SERVICE INFORMATION

LAND-ROVER PETROL AND DIESEL MODELS

The Rover Company Limited, Solihull,
Warwickshire, England

March, 1972

Fig. 2. Location of 'Salisbury' rear axle number

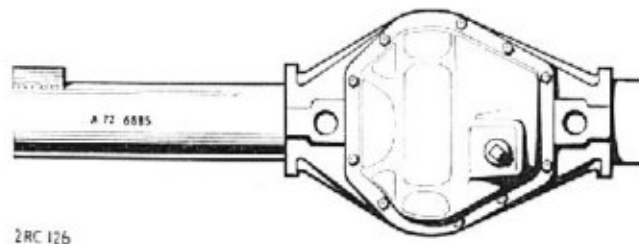
REMARKS: In Land-Rover Service News Letter, Vol. 3, No. 21a, the commencing number of the Salisbury manufactured rear axle was given as 91100001A. This is incorrect, the axles are actually numbered in the range commencing H71/43 onwards.
Distributors and Dealers are requested to amend their records accordingly.

Fig. 1 Location of bush for 4-wheel drive selector rod

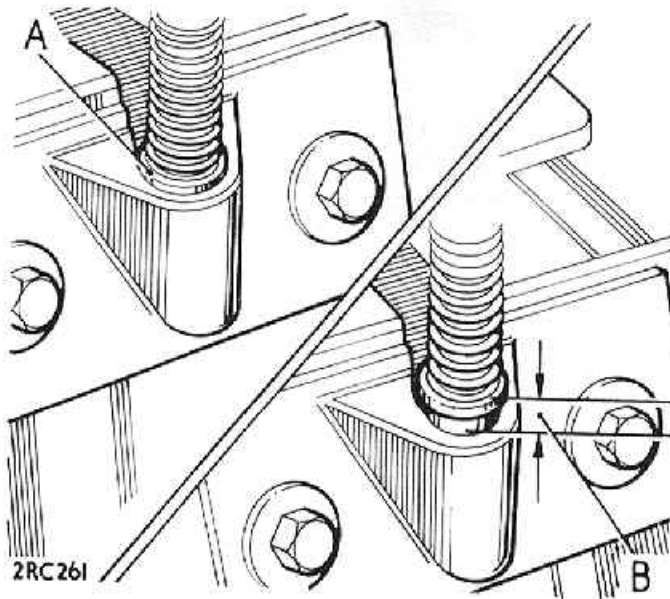
REMARKS: Recent investigations into a complaint of inability to select four wheel drive high range revealed that the selector rod return spring became coil bound. This was caused because the external diameter of the bush was too large, which prevented the bush seating properly in the cover plate.

The bush should fit almost flush with the cover plate, but with incorrect tolerances it may be approximately 50 mm ($\frac{1}{2}$ in.) too high.

Should this condition be encountered we recommend that the cover plate be removed and the hole enlarged to accommodate the bush.

Fig. 1 Correct location of solenoid feed wire

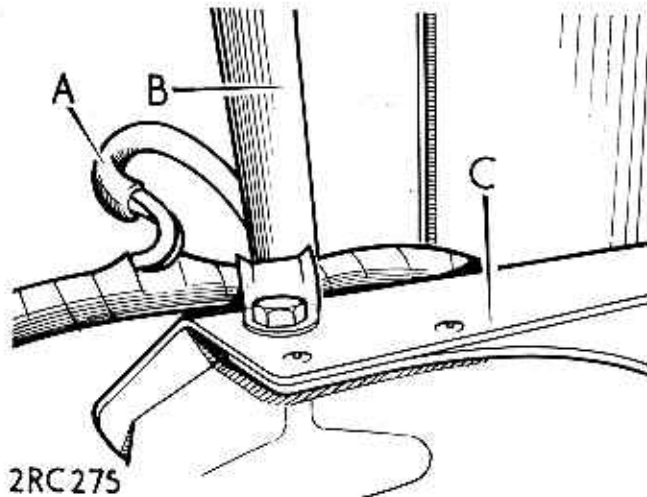
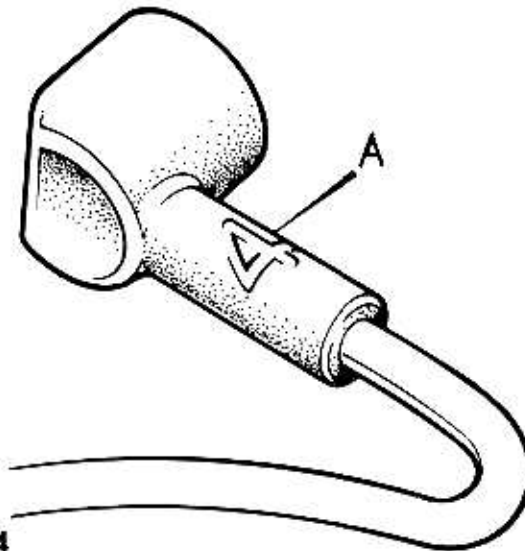
MODIFICATION: Introduction of modified main harness to prevent a foul condition between air cleaner, harness and wing valance.

- REMARKS:** It has been brought to our attention that in certain instances a 'foul' condition may be present between the air cleaner, main harness assembly and the right hand side wing valance.
- Service personnel are requested to examine all earlier vehicles, during routine maintenance checks and, if required, peel back the non-adhesive harness binding tape, thus allowing the solenoid feed wire to be re-routed away from the obstruction.
- Should the solenoid feed wire be badly chafed, it should be replaced with the modified main harness assembly.
- All Service stock of the main harness assemblies are to the latest specification.

A—Gear change lever
B—Ball end

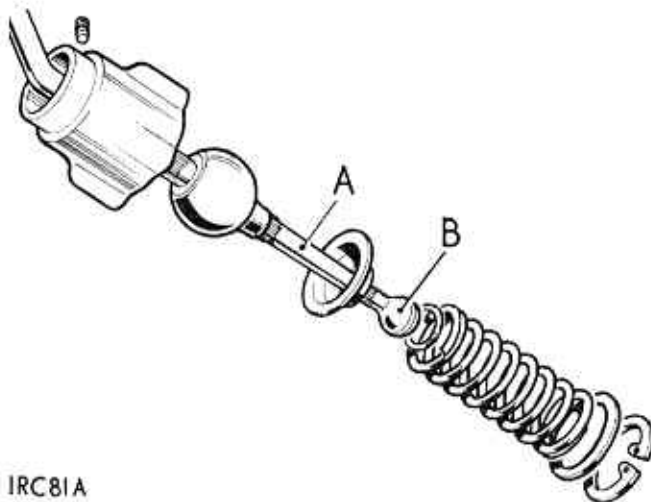
REMARKS: Over a period of time there have been instances of failure of the Polyurethane material used for the ball end attached to the gear lever on Series IIA vehicles.

Since last November this material, which is also used currently on the Series III, has been subjected to additional laboratory tests to ensure its consistency with our specification.

Any future recurrence of this problem should be satisfactorily remedied by fitting a replacement gear lever.

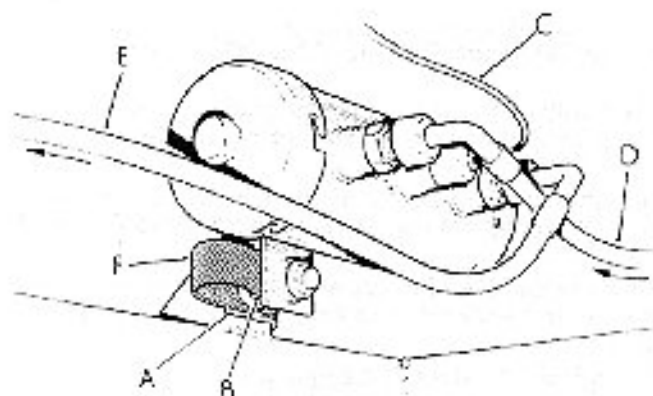
MODIFICATION: Introduction of Bendix electric fuel pump, replacing the S U fuel pump previously used, to overcome problems of corrosion.

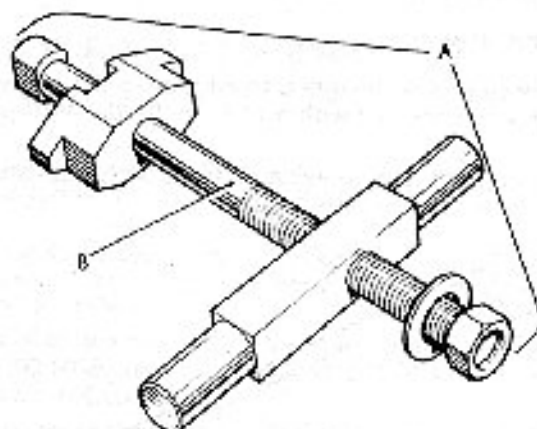
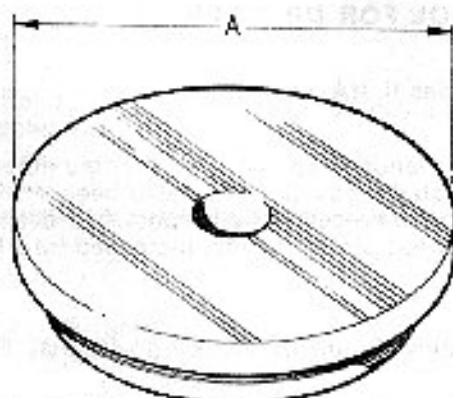
MODIFICATION: Introduction of a lengthened centre bolt for the differential pinion head bearing removal tool; the associated press block has also been modified to give improved contact with the head bearing. The centre bolt length has been increased from 180 mm (7 in.) to 230 mm (9 in.); press block diameter increased from 69 mm (2.7 in.) to 77 mm (3.0 in.).

On all Series III models and at the vehicle suffix letter change from 'G' to 'H' on Series IIA models, the pinion oil seal retainer is integral with the differential casing and not removable as previously; therefore a longer centre bolt has been provided for the Service tool used to remove and refit the pinion head bearing cup, to cater for the extra depth of casing involved.

Lengthening the centre bolt has resulted in a tool number change from 262757 (which remains suitable for early models) to 262757A which is suitable for both early and late models. The longer centre bolt is available separately under Part No. 262757A detail 3 to enable holders to modify their original tool Part No. 262757 which is then suitable for both early and late models.

In conjunction with the above modification, the opportunity has been taken to provide a new press block which gives a greater contact area with the pinion bearing cup. The new press block Part No. 262757-1 replaces the earlier press block Part No. 262758 for the following models:

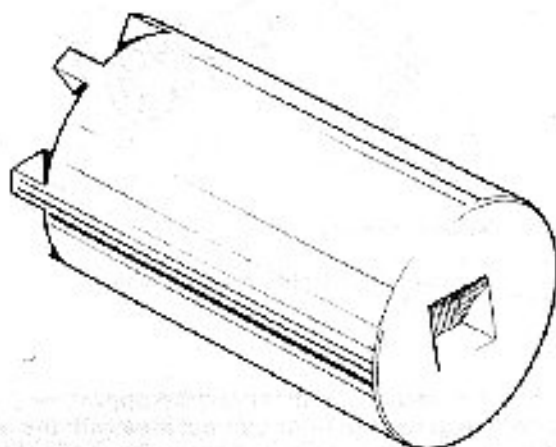
MODIFICATION: Introduction of a Service tool for removing/refitting the circular castle nut which retains the front hub driving member and the axle stub shaft.

Fig. 1 Identification of moulded 'boot' on coil to distributor HT lead
A—Moulding number

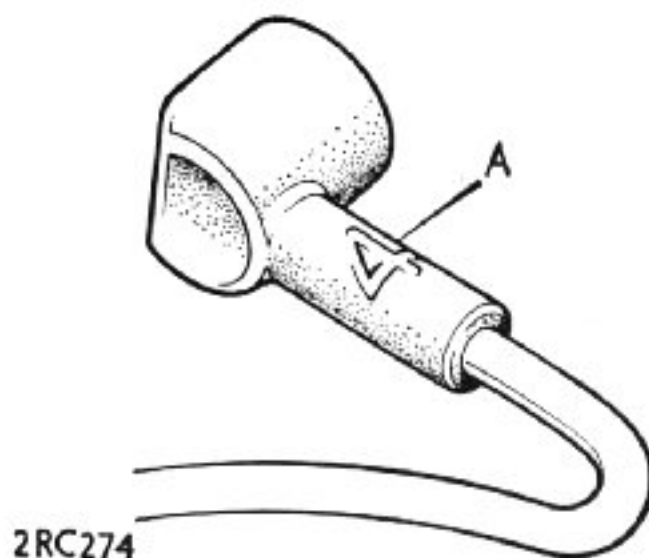
IDENTIFICATION: Moulding number 4 (see illustration below).

REMARKS: We would draw your attention to the comments made in Service Information Vol. 1 No. 6 Item 19, regarding engine misfire and indifferent starting under wet or damp conditions owing to poor moulding of the right-angled boots on a batch of H.T. leads. According to our records only a small response has been made to this information. It is, however, anticipated that the forthcoming winter will aggravate the problem and you are therefore requested to pay particular attention to this point at routine service periods or if a particular criticism is made by an owner. It is essential that any warranty claims for rectification arising from this action contain Code A326 in place of the normal warranty complaint code in order that costs may be correlated. Warranty claims for rectification will not be accepted after 5th February 1973.

**Fig. 2 Clutch release bearing and sleeve assembly**A—'Ferrobestos' sleeve
B—Sealed bearing
C—'Loctite' bonded joint

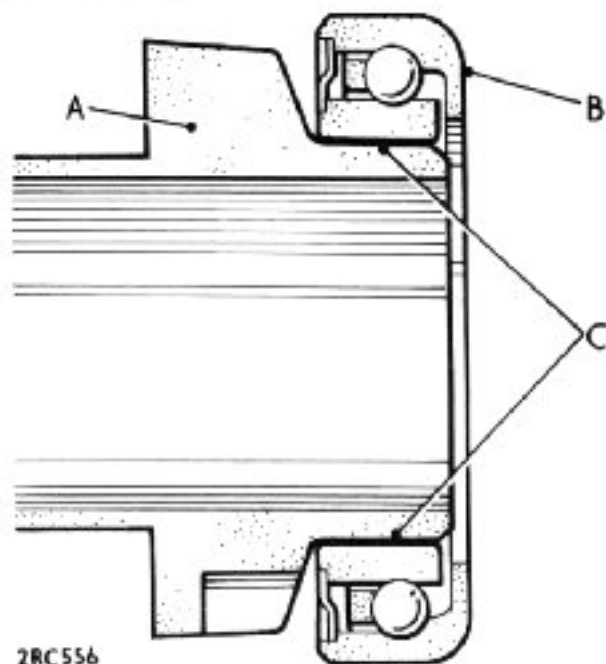
The above modification has been introduced to reduce the possibility of the clutch release sleeve becoming seized on the front cover extension during arduous driving conditions and to improve the bearing lubrication.

The assembly comprises a sleeve manufactured from 'Ferrobestos' and a new release bearing which is packed with grease and sealed. These are bonded together by Loctite high strength retaining compound.

The assembly is interchangeable with the earlier bearing and sleeve but is only available as a complete assembly.

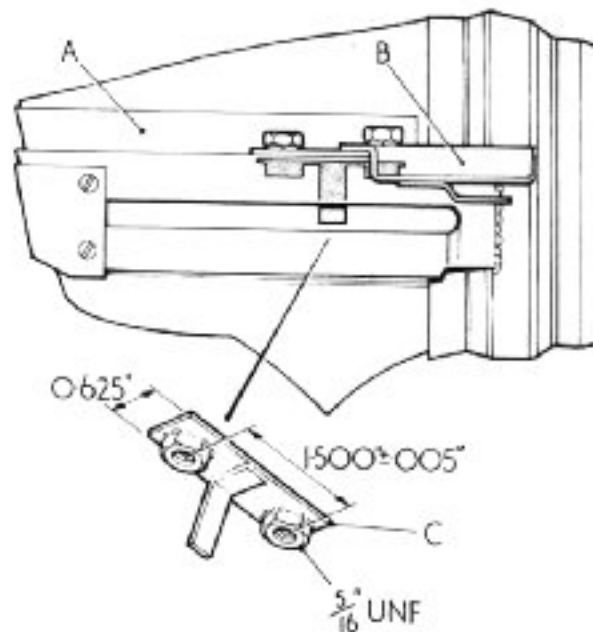
MODIFICATION: Addition of a pivot bracket to convert a Series III door to fit Series II and IIA vehicles.

REMARKS: To enable a Series III type door to be used on Series II and IIA vehicles the above assembly is bolted on to the intermediate member already provided on the Series III door frame for check strap attachment.

NOTE: Since difficulty has been experienced in locating and retaining the nuts in the intermediate member while tightening the bracket fixing screws, a nut plate assembly Part No. 347511 will eventually be supplied for this conversion in place of the four plain washers and nuts specified above.

In the meantime it is recommended that a nut plate is manufactured to facilitate assembly.

Fig. 1 Inlet manifold butterfly valve

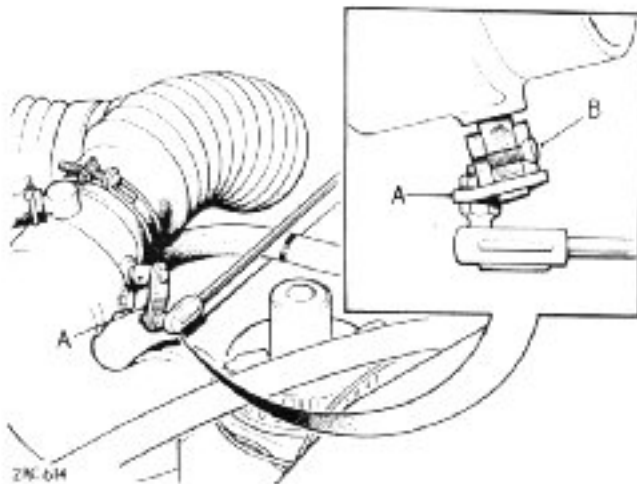
If this condition is present on a vehicle, it can cause either a loss of vacuum or excessive smoke to be emitted from the exhaust. Should Distributor or Dealer personnel come across this problem they are advised to first check the positioning and tightness of the clamp screw. If the component is found to be loose it is recommended 'Studlock' or 'Loctite' is applied and the screw re-tightened.

Production Department, as an interim measure, from April, 1972, have been applying 'Studlock' on the screw. To overcome this possible condition permanently, however, it is anticipated that a re-design of the particular area concerned will be carried out.

Fig. 2 Distance piece for inner hub bearing

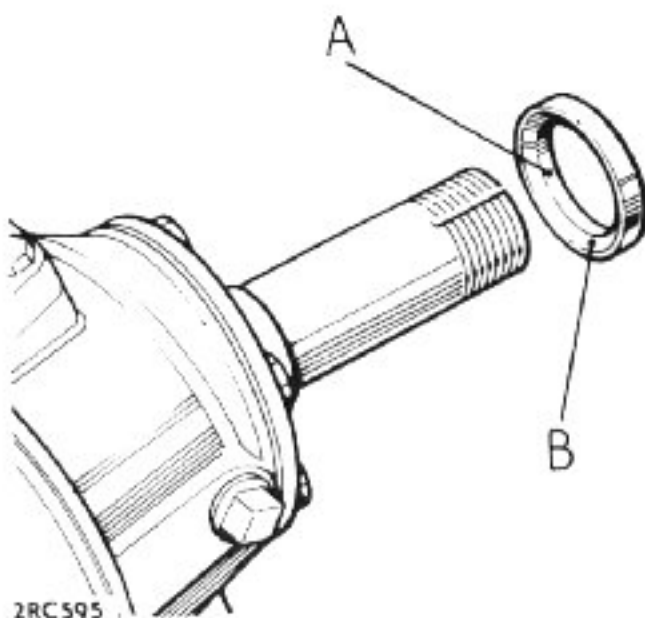
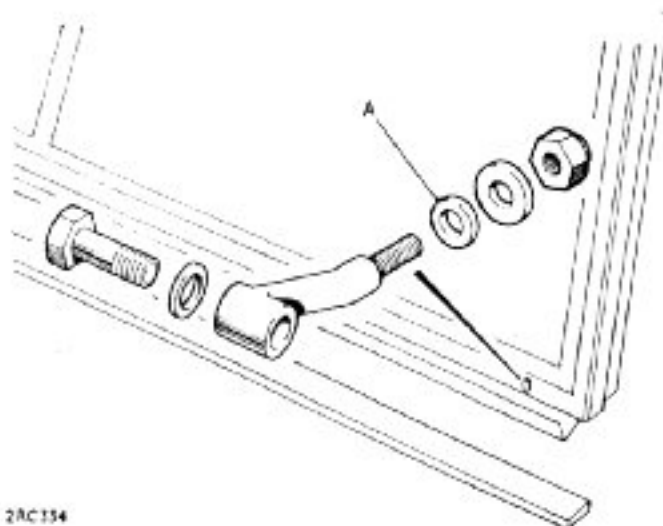
MODIFICATION: Introduction of mild steel distance piece to eliminate oil leaks arising from previous sintered iron type.

NOTE: Because of the material change the mild steel distance piece cannot be removed in the same way as the sintered iron type.

In this case, it is recommended that, by exercising reasonable care the distance piece can be partially cut through with a sharp chisel to loosen it, when it can be gently prised off.

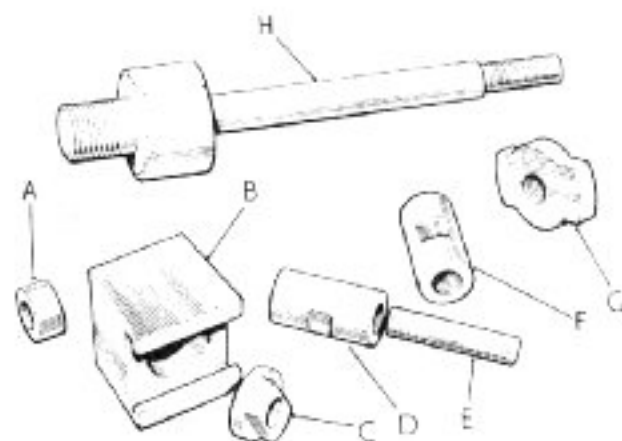
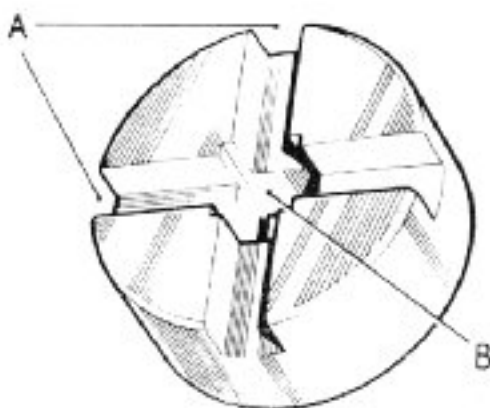
MODIFICATION: Introduction of an adaptor kit to suit impulse tool 18G284, to aid commonisation. The kit also provides all the adaptors previously included with impulse tool 530101.
